Safety Notice

170004

Date:	September 22, 2017
Affected Option:	Operator Protective Alarm (OPA)
Models and Serial Numbers Affected:	See pages 4 to 6
Field Install Kits Affected:	125563 - for all Z-45/25 DC models 1255096 and 1276063 - for machines equipped with ALC500 operating system 1255564 and 1273064 - for machines equipped with ALC1000 operating system.
Subject:	Operator Protective Alarm (OPA) mounting
Allowable Hours:	1 hour

This Safety Notice requires installing a reinforcement structure around the OPA assembly.

Illustration 1

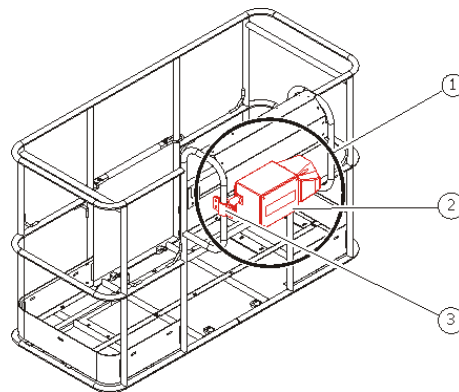
Genie has determined that the Operator's Protective Alarm (OPA) installed on any of the models listed on page 6 is equipped with a mounting bracket that may become loose. **This may cause the OPA assembly to fall off the machine resulting in a collision hazard.**

Illustration 4

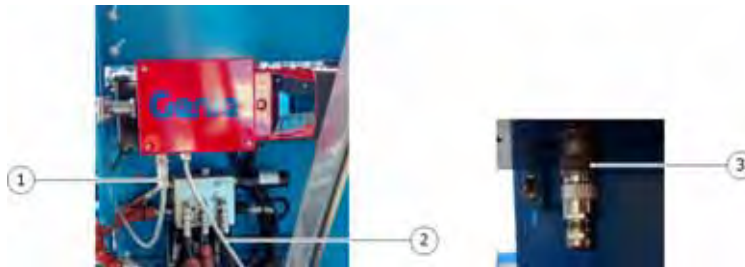
You may continue using the OPA assembly with the machine. However, the OPA assembly must be removed from the machine before transport. Re-install the OPA assembly at the worksite.

- 1 Locate the OPA harness connectors (items 1 and 2).

- 2 Disconnect harness connector 1 from the red OPA control box. Secure the harness.
- 3 Disconnect harness connector 2 from the platform control box or footswitch. Secure the harness.
- 4 Locate the blanking plug (Genie part number 1255030GT) from the machine document box and plug into the platform or footswitch connector where harness connector 2 was removed.
